FOUNDATION INVESTIGATION REPORT
 For
 Eastbound Lane and Westbound Lane
 Structures at the Crossing of
 Ramsay Creek and Proposed Hwy. #417
 District No. 9 (Ottawa)
 W.J. 68-F-54 -- W.P. 34-66-02 10-11

FOUNDATION INVESTIGATION REPORT
For
Eastbound Lane and Westbound Lane
Structures at the Crossing of
Ramsay Creek and Proposed Hwy. #417
District No. 9 (Ottawa)
W.J. 68-F-54 -- W.P. 34-66-01 10-11

Ramsay Creek Culvert
Hwy. #417 (E.B.L.)
Regional Municipality of Ottawa-Carleton
District S.S. (Ottawa)
W.O. 68-11054 - W.P. 84-66-10

STRUCTURE PROTECTION SHEET
RAMSAY CREEK BRIDGE E.B.L. 61

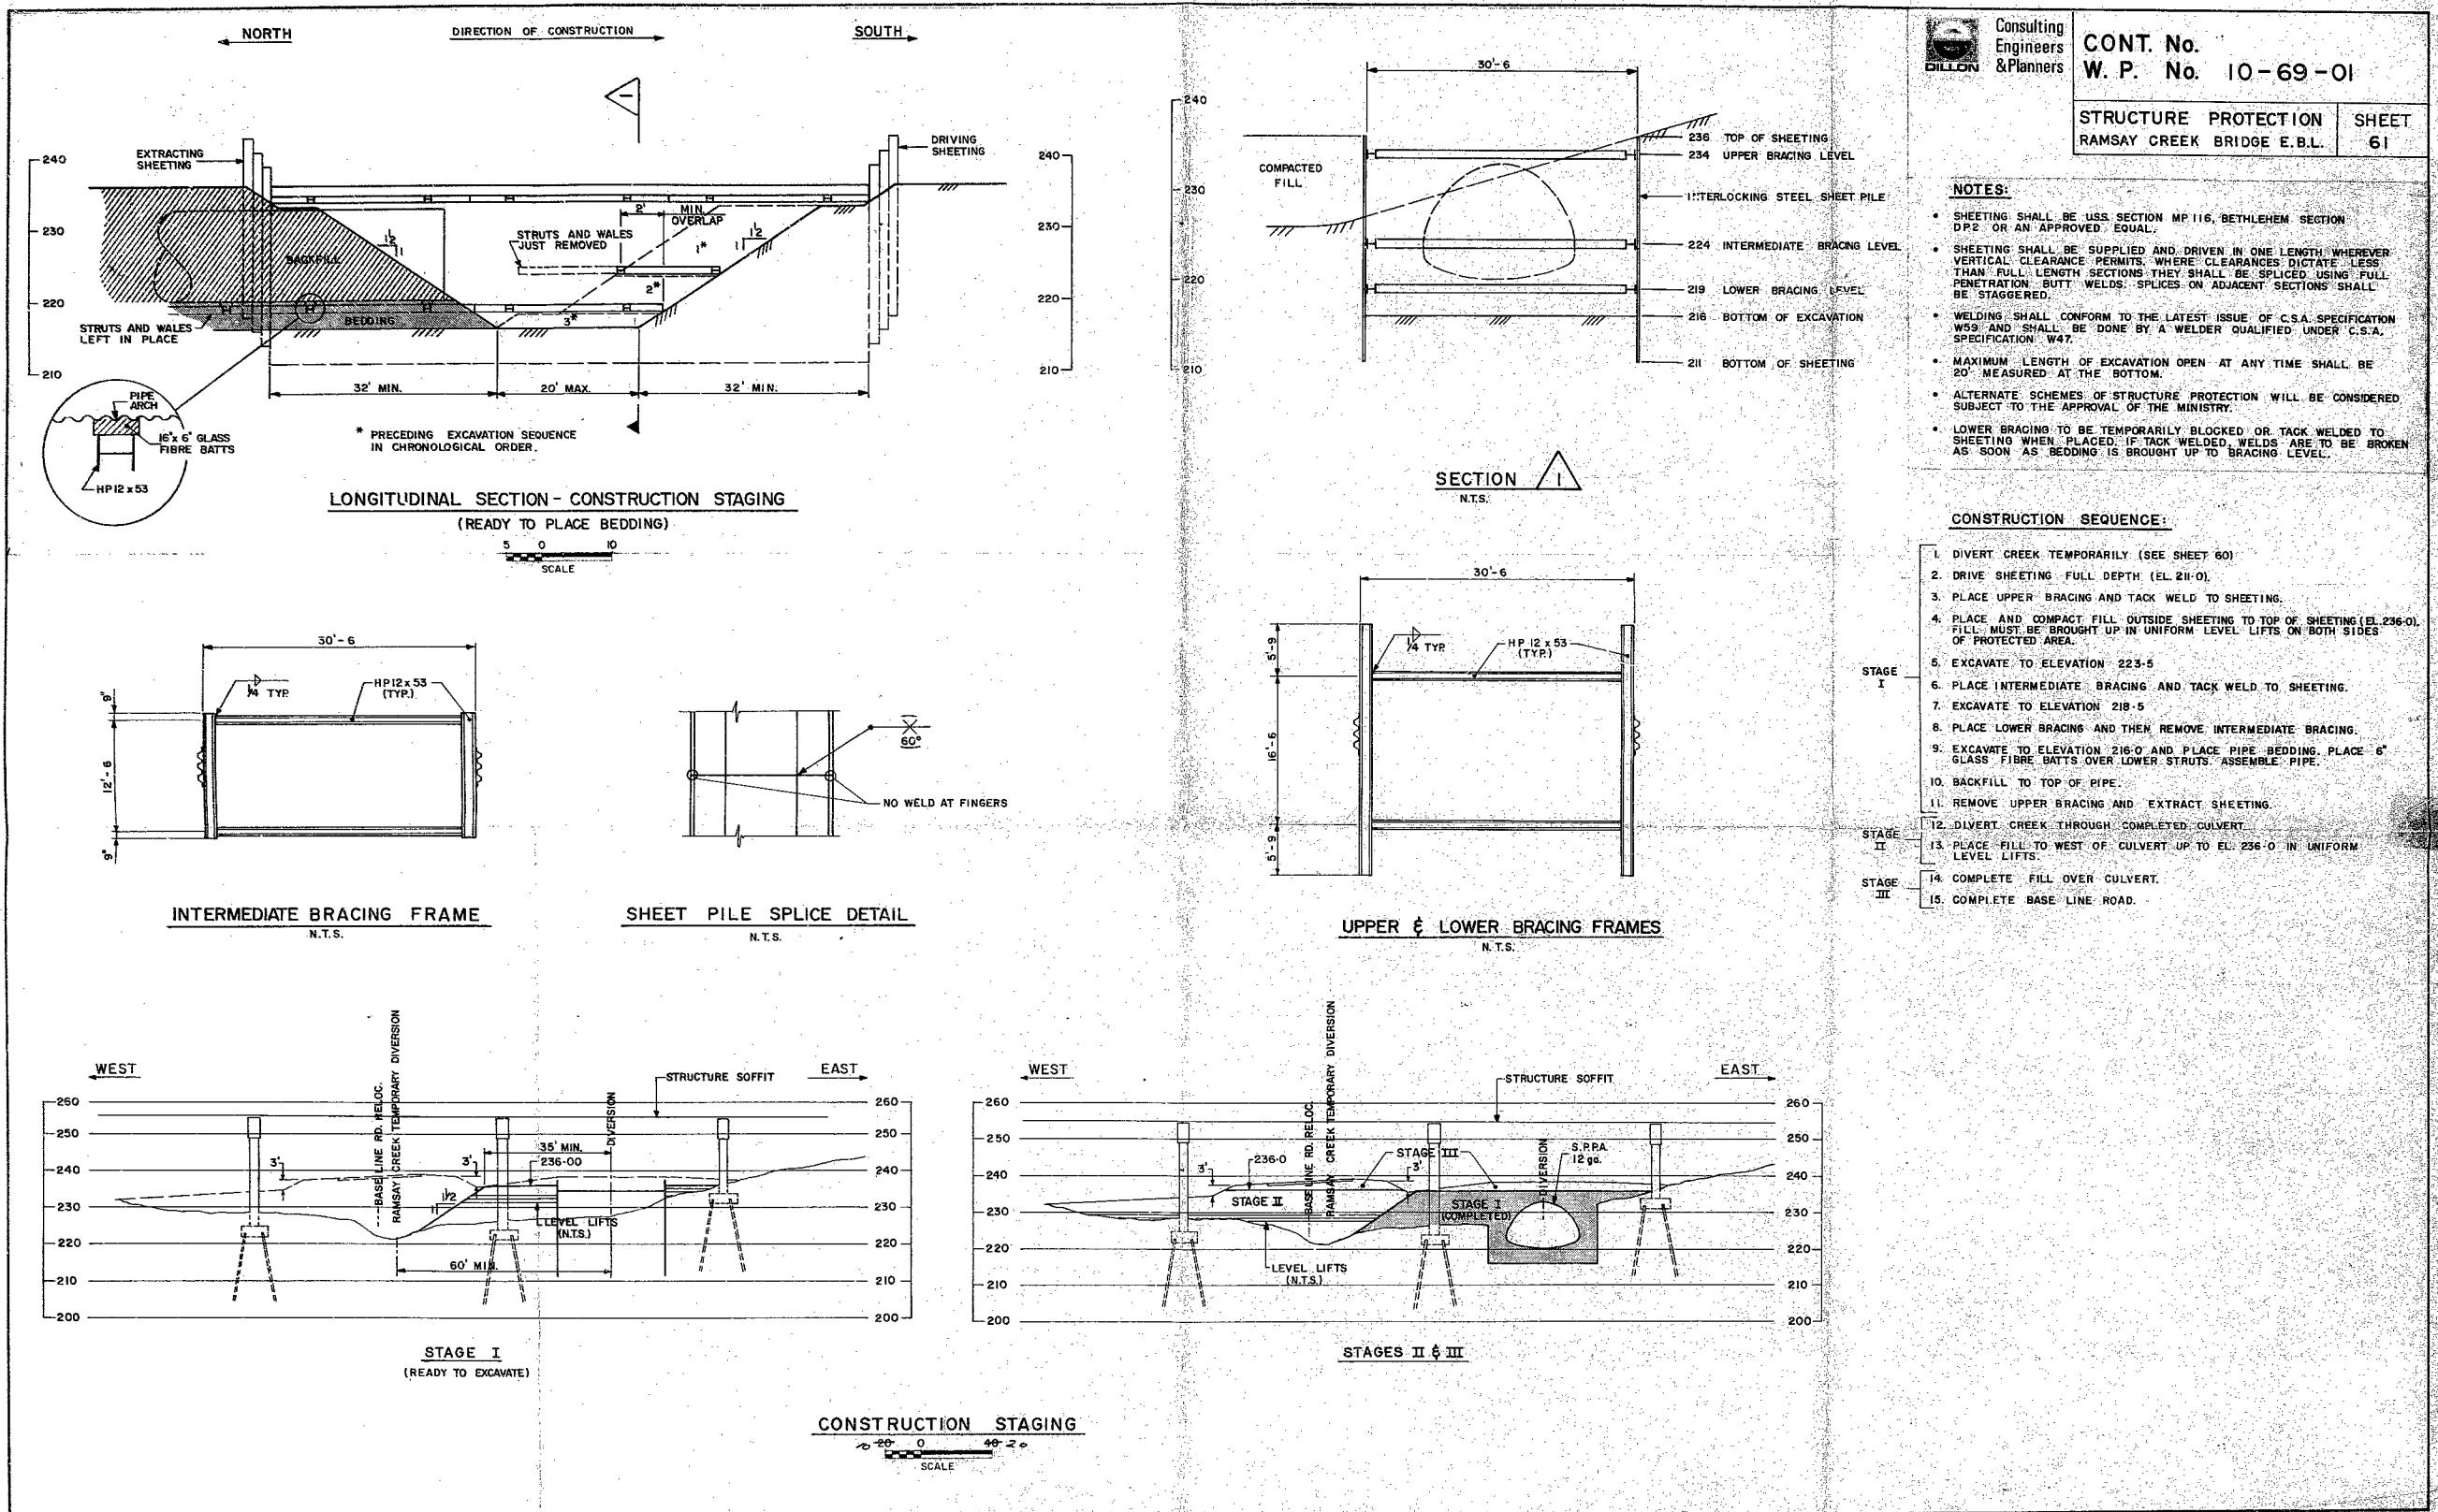
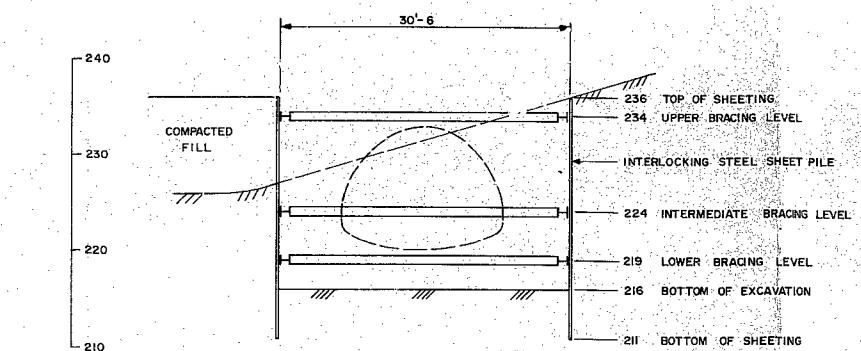
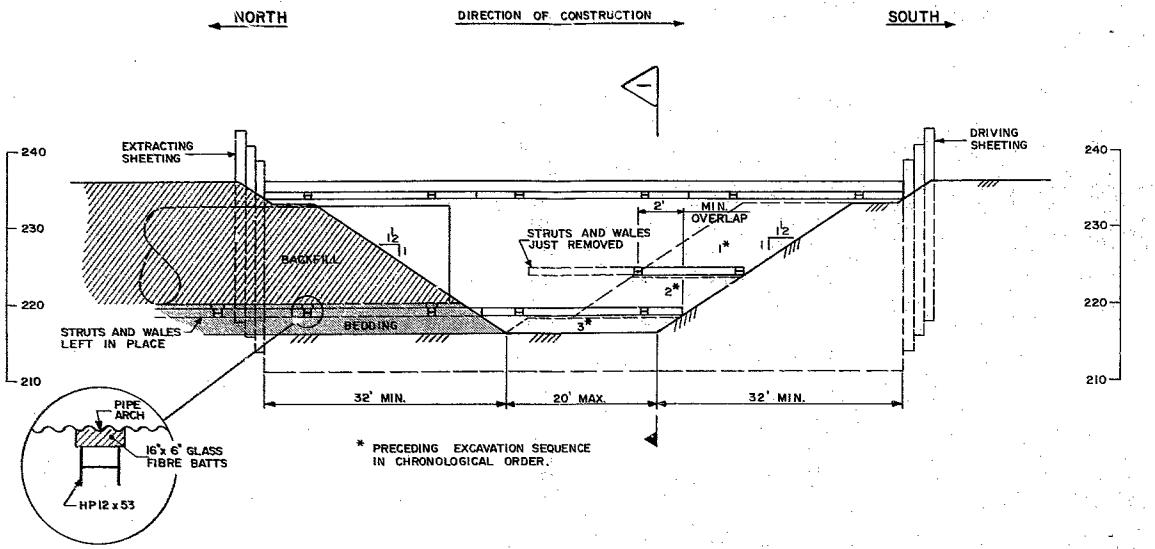
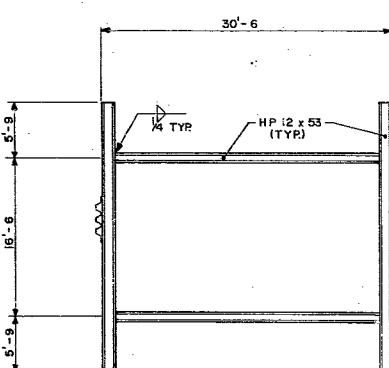
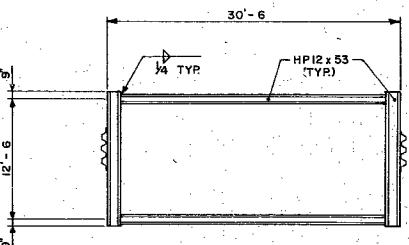
Advised W. Irwin that an item, stating that the excavation for the culvert should be carried out in 20-foot lengths, should be added to the "Construction Sequence", although this was shown in the longitudinal section.
